# DERBY HALL CHURCH

## Section 96A (NMA Statement)

PROJECT NO: AI-2456

STATUS: SECTION 96A PLANNING SUBMISSION

Level GROUND FLOOR

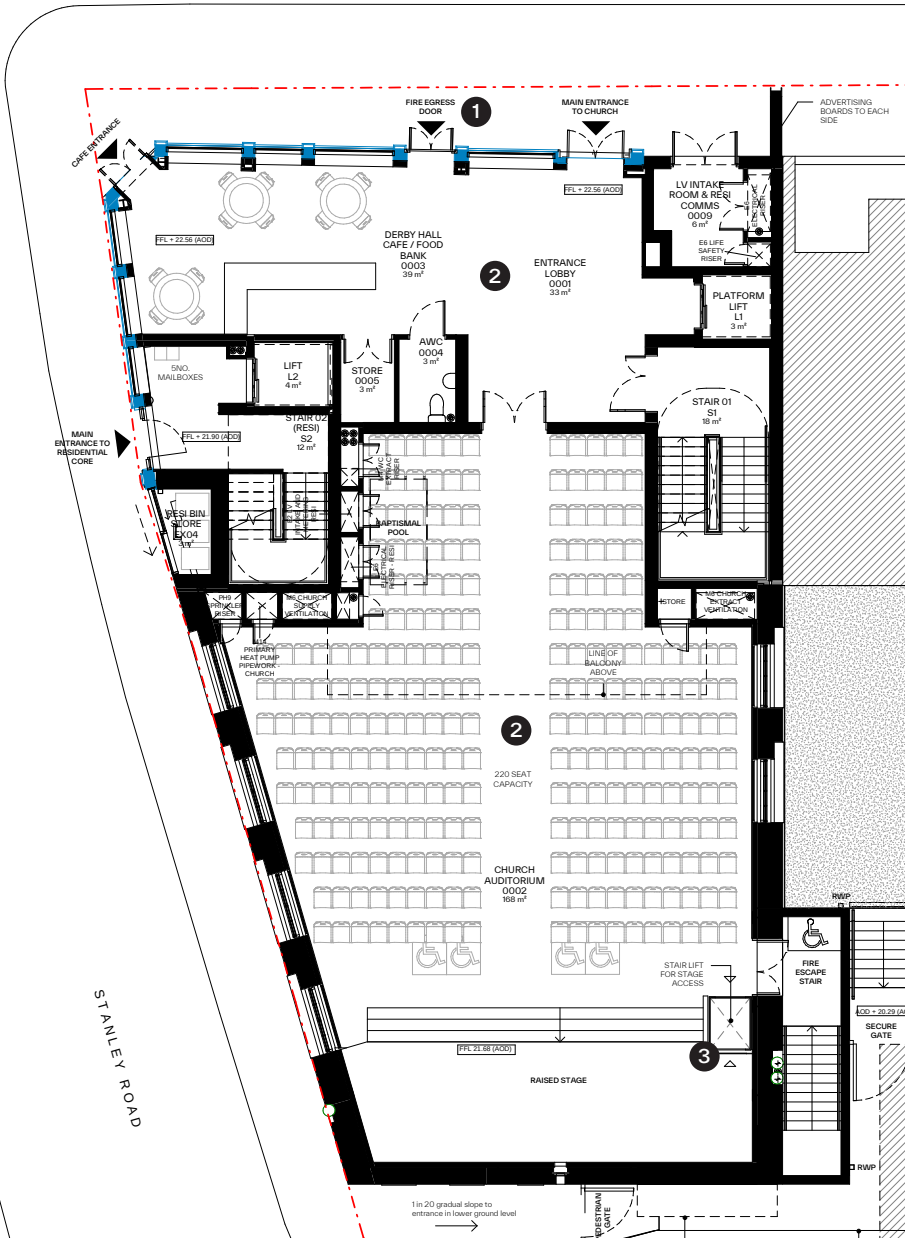
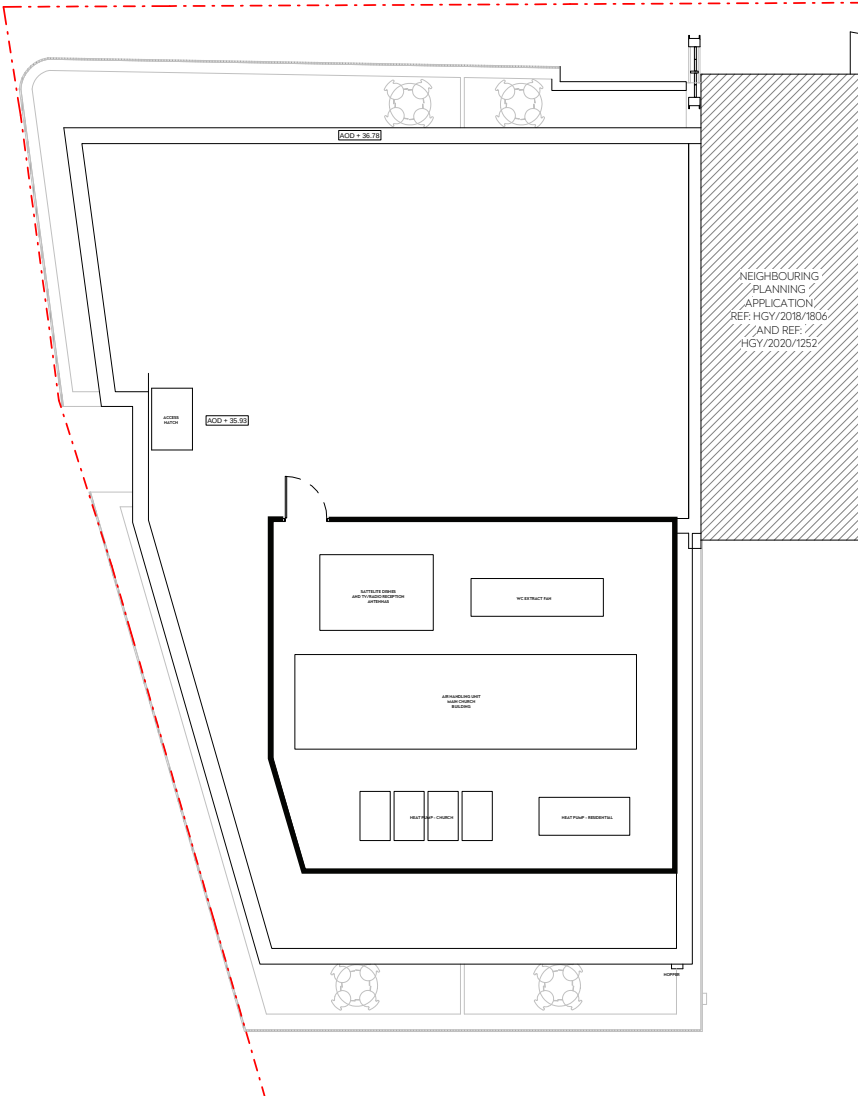
- 1 Existing opening maintained to work as fire egress door. Door replaced with similar
- 2 Minor changes to internal layout
- 3 Platform lift introduced for Part M compliance

ROOF LEVEL  
PROPOSED

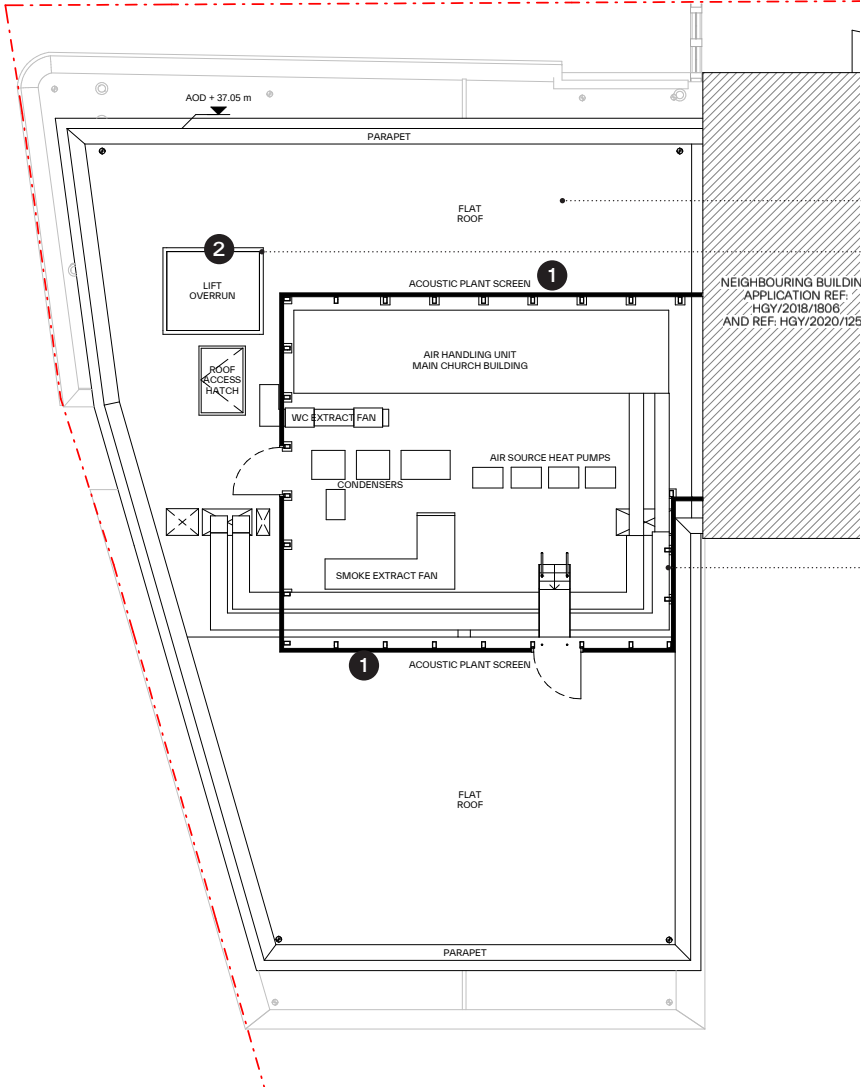
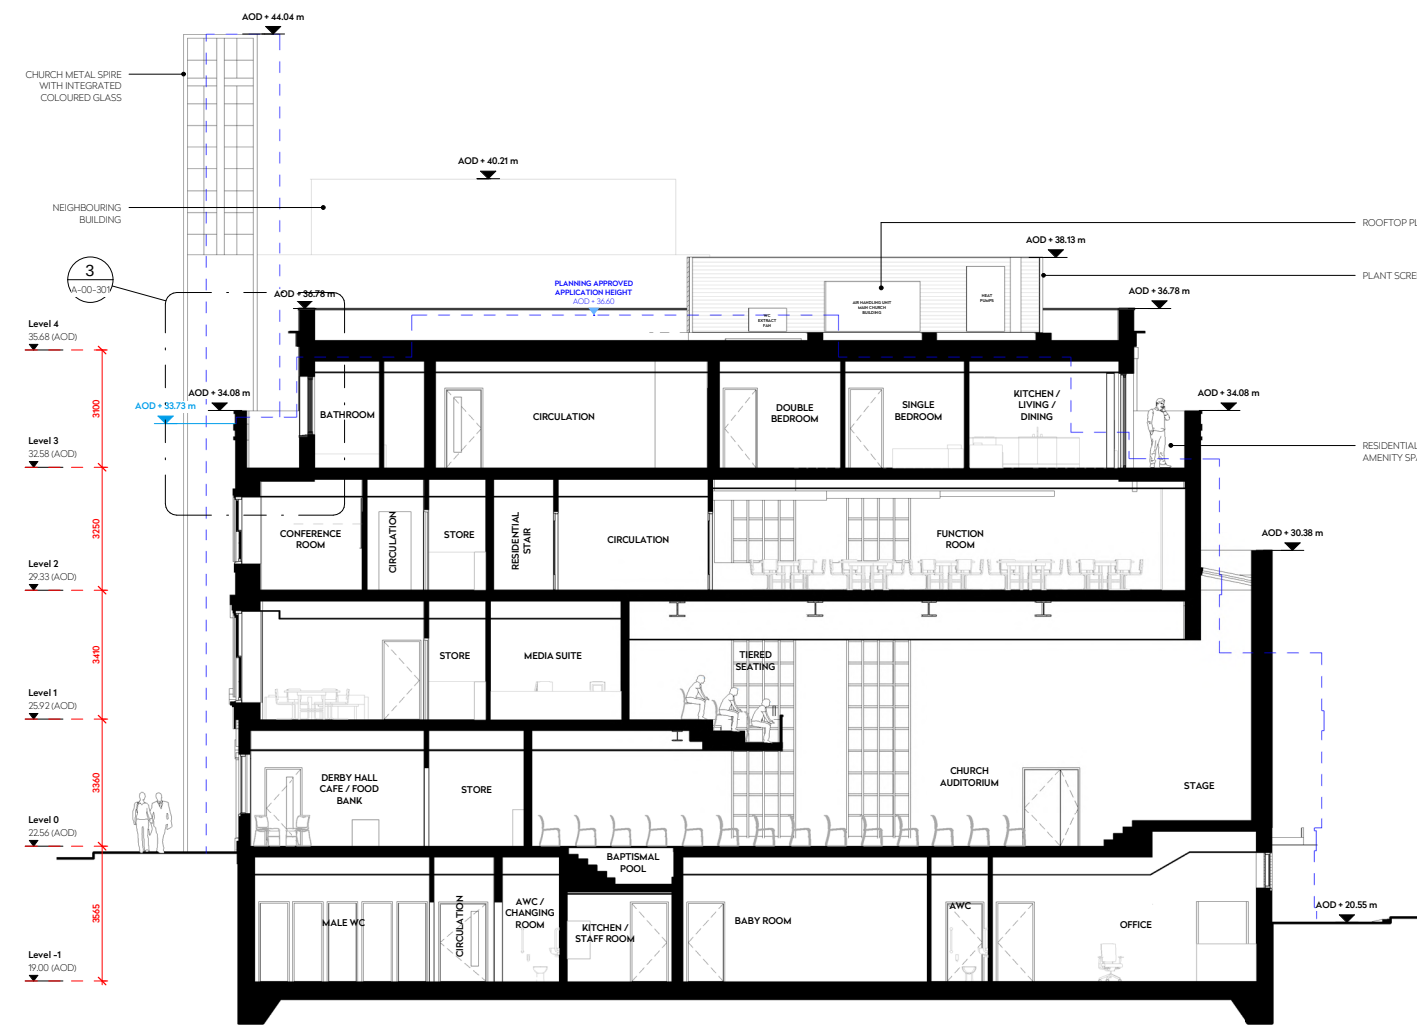
Mansafe system provided for safe roof access.

Lift overrun doesn't project above the parapet line

Roof plant moved away from residential windows of neighbouring properties to comply with planning noise levels

1 Roof plant sized adjusted and moved away from residential windows of neighbouring properties to comply with planning noise levels

2 Lift overrun doesn't project above the parapet line

APPROVED / PROPOSED SECTIONS  
NORTH/SOUTH Section

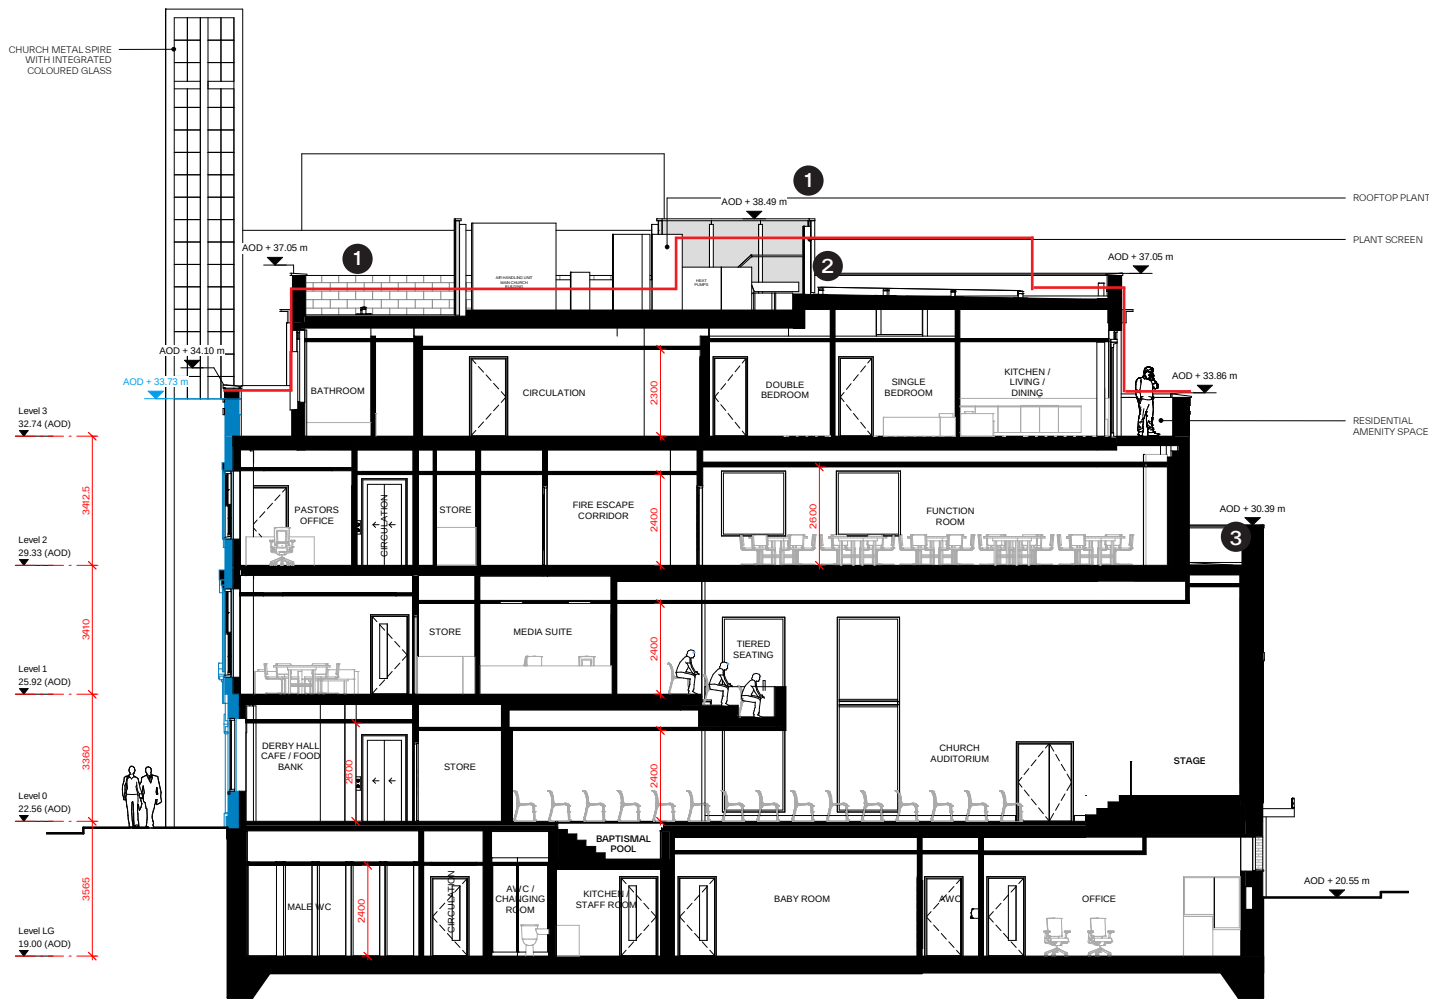
- 1 Parapet levels slightly raised following detailed coordination with structure and MEP.
  - 2 Roof plant moved away from residential windows of neighbouring properties to comply with planning noise levels
  - 3 Rooflight omitted to limit natural light into the auditorium
- Line showing approved massing for comparison (approximate)

## NORTH Elevation

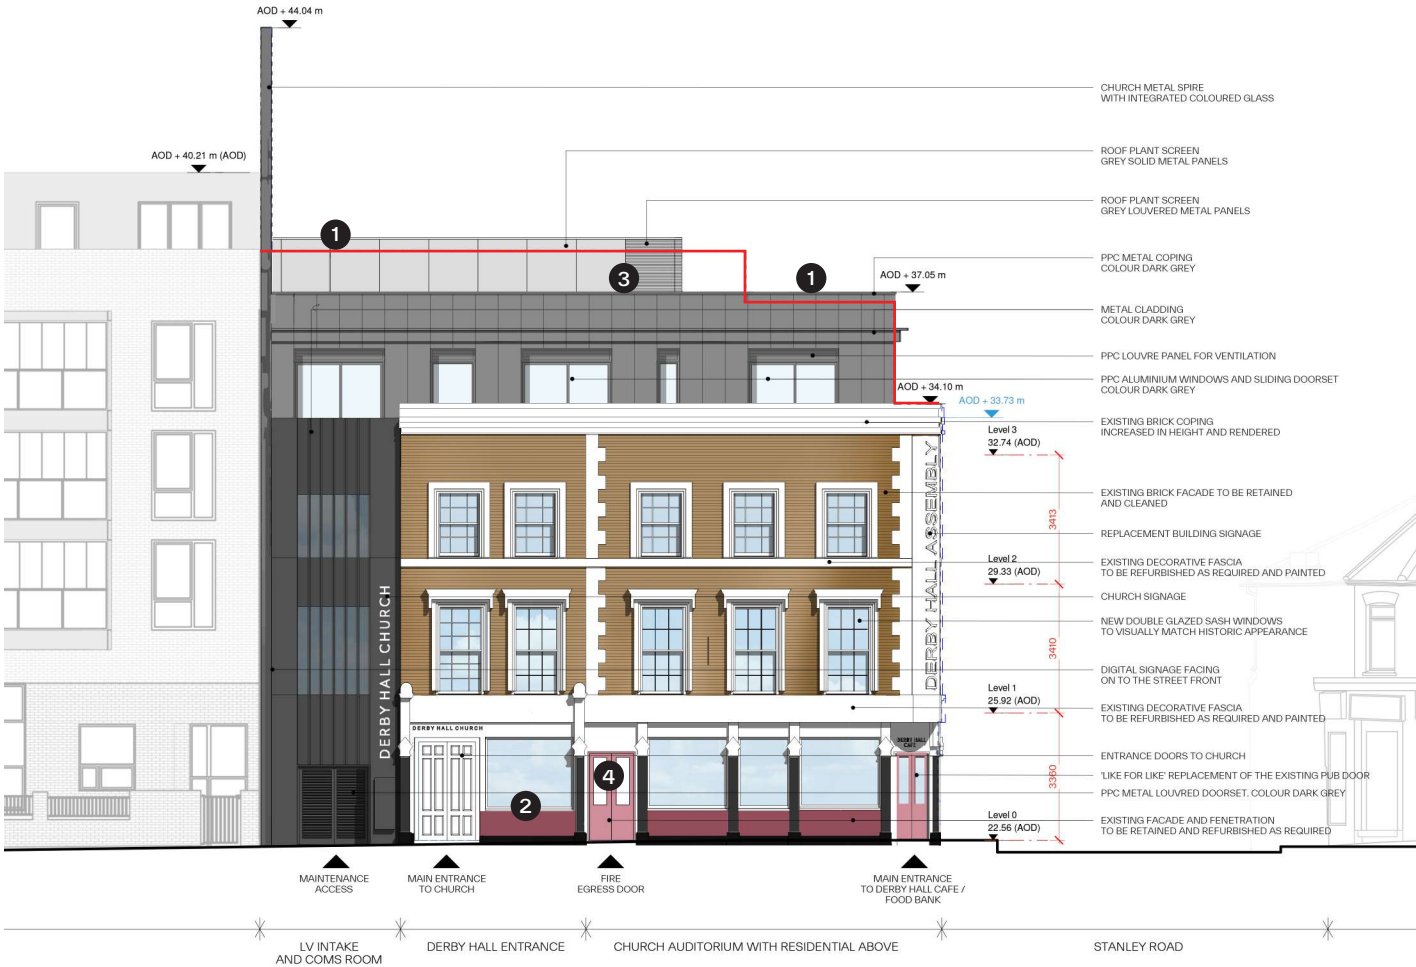
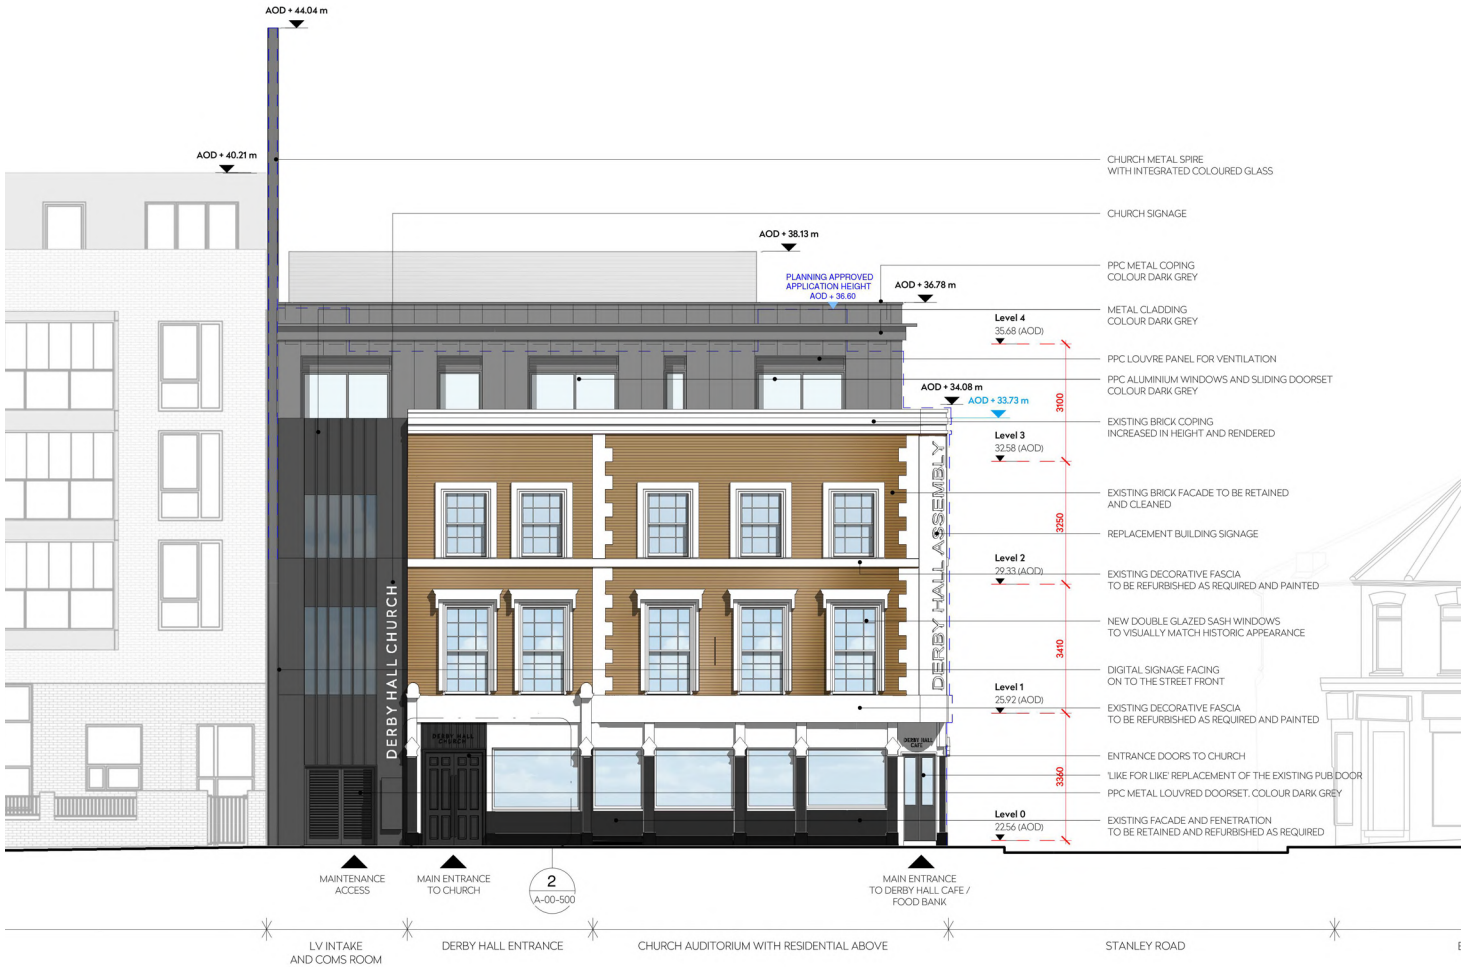
- 1 Parapet levels and plantroom screen slightly raised following detailed coordination with structure and MEP.
  - 2 Pub elevation maintained as much as possible as original
  - 3 Roof plant sized adjusted and moved away from residential windows of neighbouring properties to comply with planning noise level. Solid and louvered panels required on roof plant screen to comply with acoustic and ventilation requirements
  - 4 Existing opening maintained to work as fire egress door. Door replaced with similar
- Line showing approved massing for comparison (approximate)

## WEST Elevation

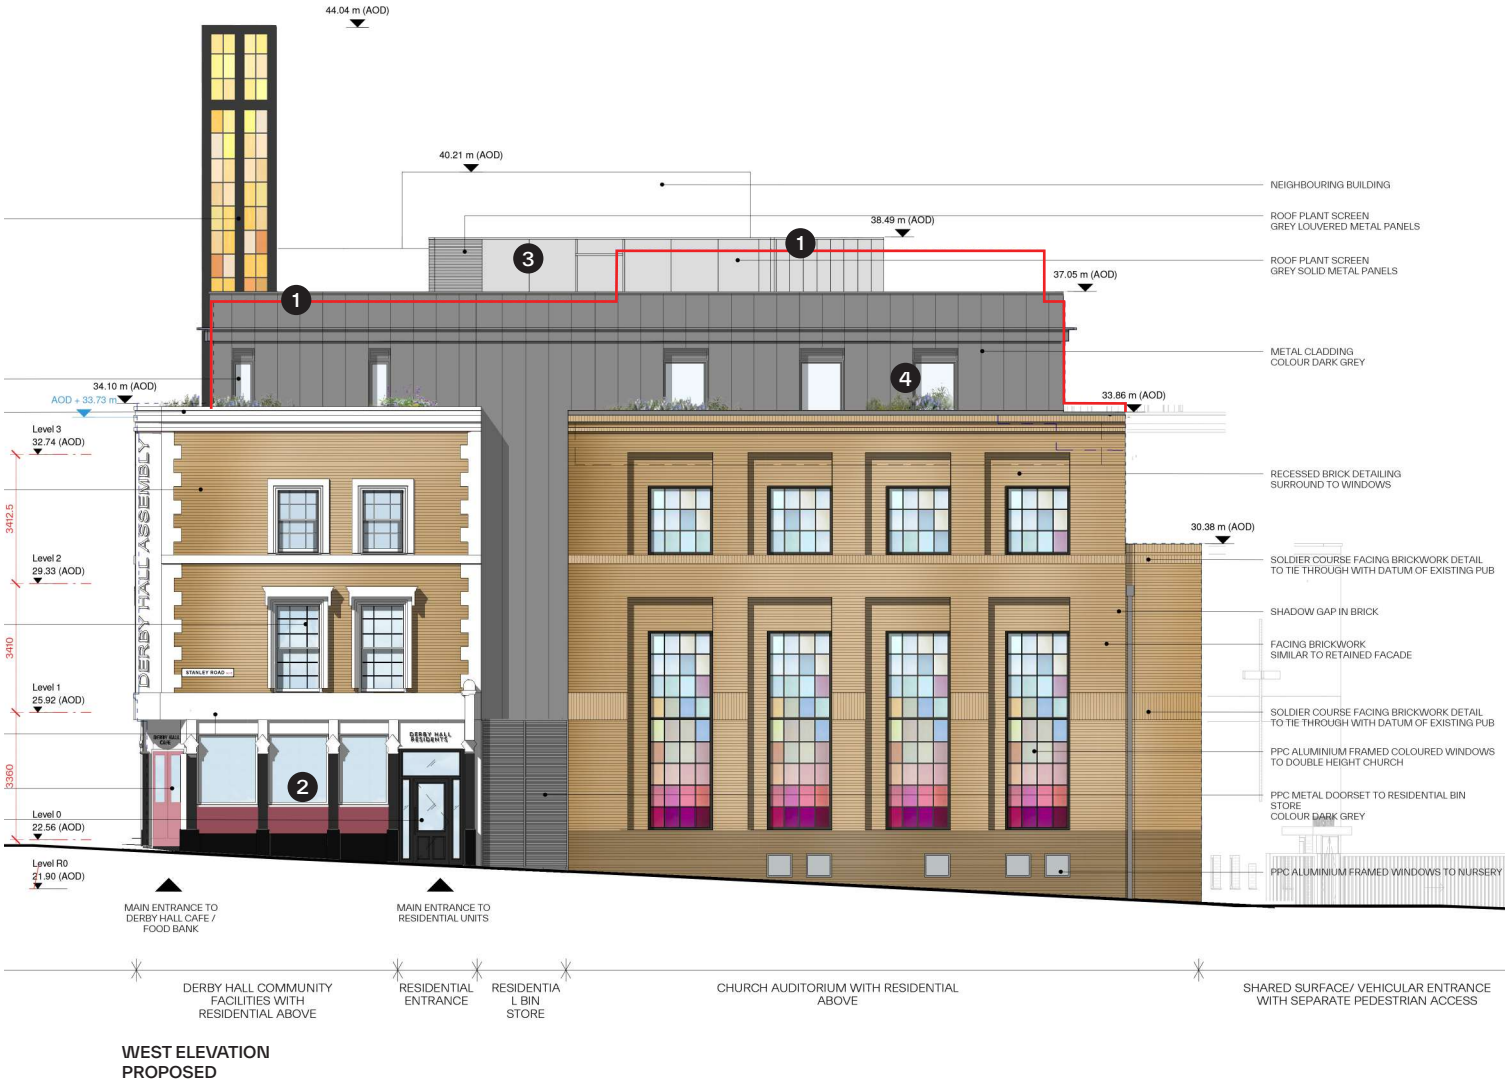
- 1 Parapet levels and plantroom screen slightly raised following detailed coordination with structure and MEP.
  - 2 Pub elevation maintained as much as possible as original
  - 3 Roof plant sized adjusted and moved away from residential windows of neighbouring properties to comply with planning noise level. Solid and louvered panels required on roof plant screen to comply with acoustic and ventilation requirements
  - 4 Minor modification of window position
- Line showing approved massing for comparison (approximate)
